The Commission has issued the enclosed Amendments Nos. 52, 47 and 24 to Facility Licenses Nos. DPR-33, DPR-52 and DPR-68 for the Browns Ferry Nuclear Plant Units Nos. 1, 2 and 3. These amendments consist of changes to the Technical Specifications in response to your request of January 5, 1979 (TVA BFP TS 119).

The amendments authorize you to substitute a computational thermal model for in-situ temperature monitoring stations to determine compliance with the mixing zone temperature limits and the State of Alabama water temperature standards.

BROWNS FERRY NUCLEAR PLANT, UNIT NO. 1

AMENDMENT TO FACILITY OPERATING LICENSE

Figure 2.1-1
Location of Water Temperature Monitors in Wheeler Reservoir
Browns Ferry Nuclear Plant

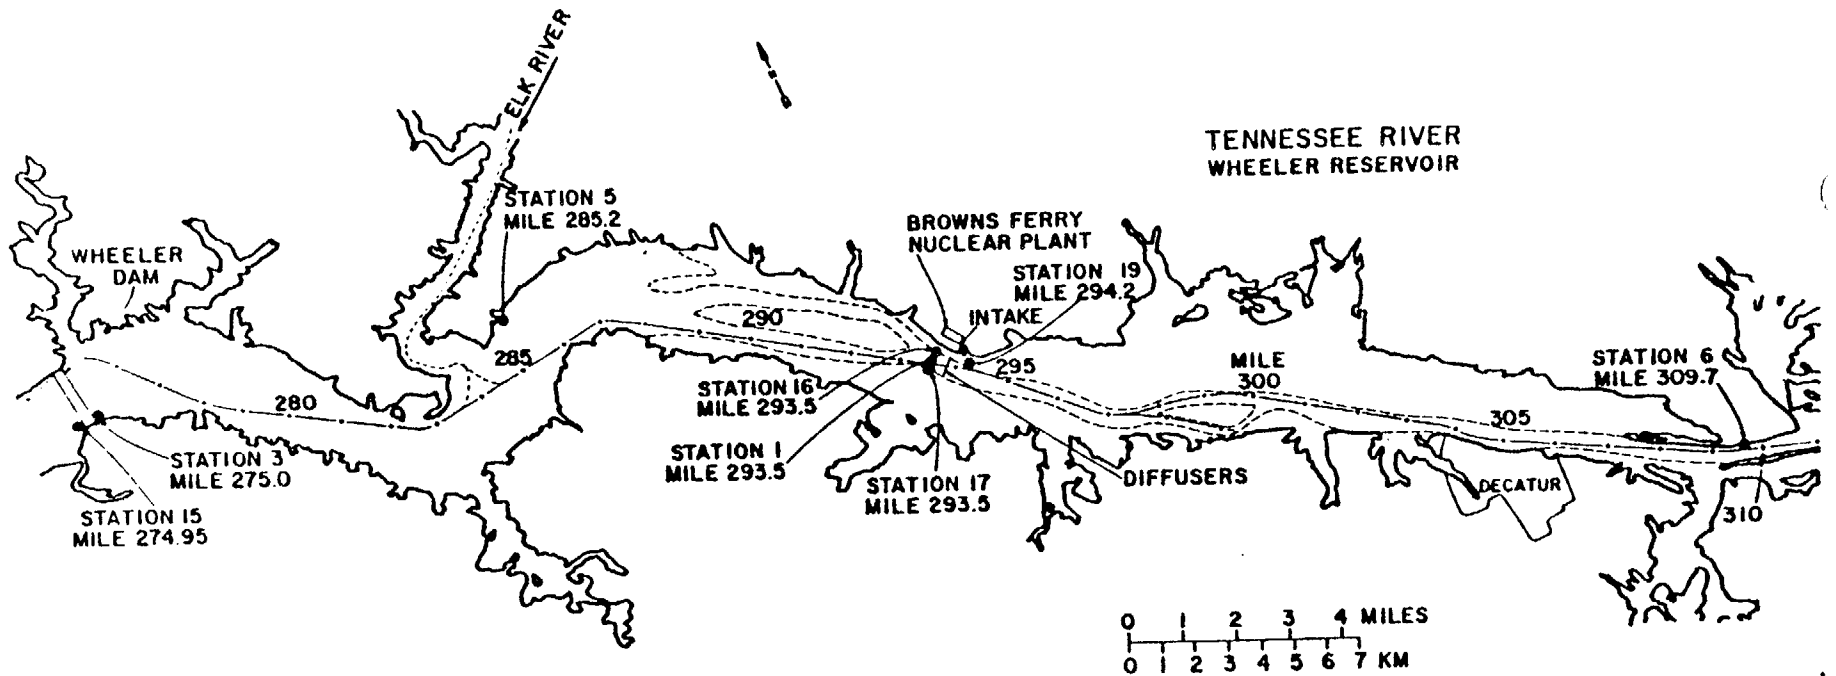
Reservoir water temperatures used to help show compliance with applicable standards will be measured at the one-meter and two-meter depths and averaged to give a temperature applicable to the five-foot depth, which is the point of application of the current Alabama temperature standards. Three thermal monitors spaced across the reservoir in the vicinity of river mile 293.5 shall be used to measure downstream mixed water temperatures. The system is designed so that the downstream monitors serve as backup for one another. The accuracy of the monitoring equipment and the sensitivity of the thermistor sensors are designed to be $\pm 0.3^\circ\text{F}$ and 0.01°F , respectively. The locations of temperature monitors are displayed in Figure 2.1-1.

The plant-induced temperature rise shall be computed using a computer model for the mixing of the plant discharge. This model requires measured plant data as well as downstream reservoir temperatures as inputs and will be updated as necessary to reflect current understanding of discharge mixing predictions.

Figure 2.1-1
Location of Water Temperature Monitors in Wheeler Reservoir
Browns Ferry Nuclear Plant

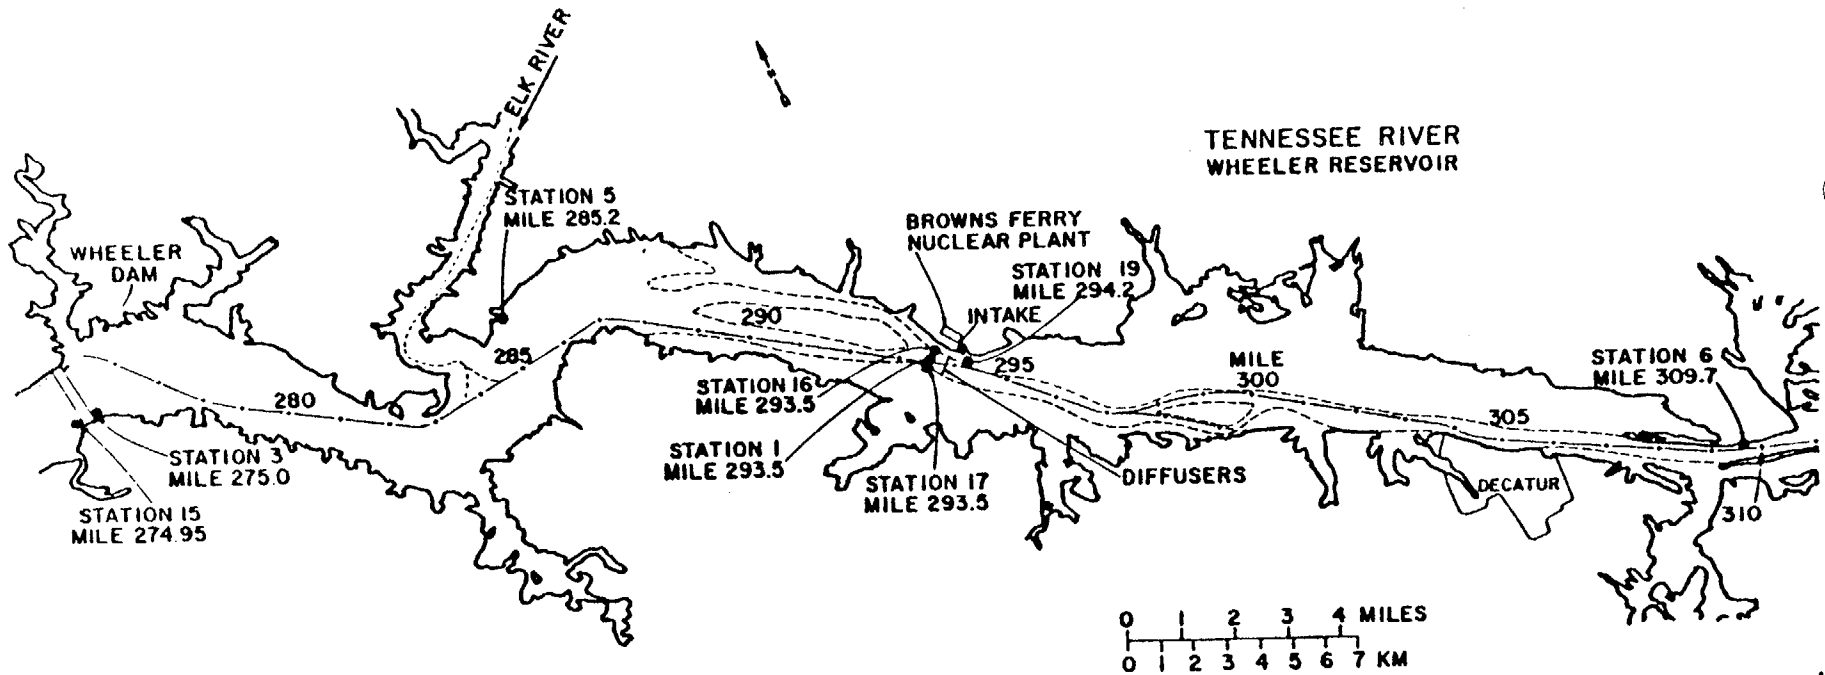
Reservoir water temperatures used to help show compliance with applicable standards will be measured at the one-meter and two-meter depths and averaged to give a temperature applicable to the five-foot depth, which is the point of application of the current Alabama temperature standards. Three thermal monitors spaced across the reservoir in the vicinity of river mile 293.5 shall be used to measure downstream mixed water temperatures. The system is designed so that the downstream monitors serve as backup for one another. The accuracy of the monitoring equipment and the sensitivity of the thermistor sensors are designed to be ±0.3°F and 0.01°F, respectively. The locations of temperature monitors are displayed in Figure 2.1-1.

The plant-induced temperature rise shall be computed using a computer model for the mixing of the plant discharge. This model requires measured plant data as well as downstream reservoir temperatures as inputs and will be updated as necessary to reflect current understanding of discharge mixing predictions.

Figure 2.1-1
Location of Water Temperature Monitors in Wheeler Reservoir
Browns Ferry Nuclear Plant

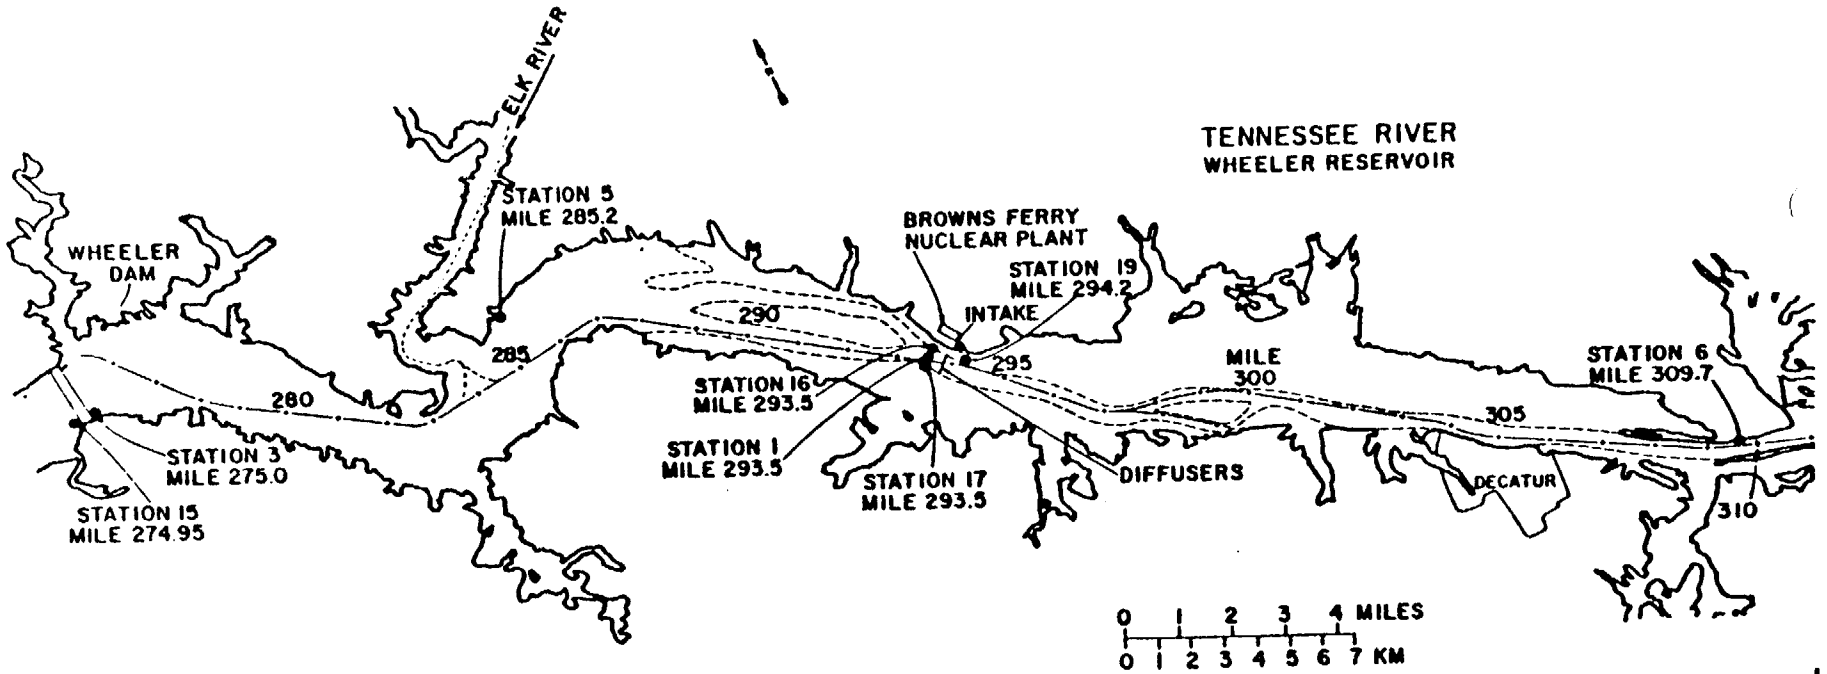
Reservoir water temperatures used to help show compliance with applicable standards will be measured at the one-meter and two-meter depths and averaged to give a temperature applicable to the five-foot depth, which is the point of application of the current Alabama temperature standards. Three thermal monitors spaced across the reservoir in the vicinity of river mile 293.5 shall be used to measure downstream mixed water temperatures. The system is designed so that the downstream monitors serve as backup for one another. The accuracy of the monitoring equipment and the sensitivity of the thermistor sensors are designed to be ±0.3°F and 0.01°F, respectively. The locations of temperature monitors are displayed in Figure 2.1-1.

The plant-induced temperature rise shall be computed using a computer model for the mixing of the plant discharge. This model requires measured plant data as well as downstream reservoir temperatures as inputs and will be updated as necessary to reflect current understanding of discharge mixing predictions.
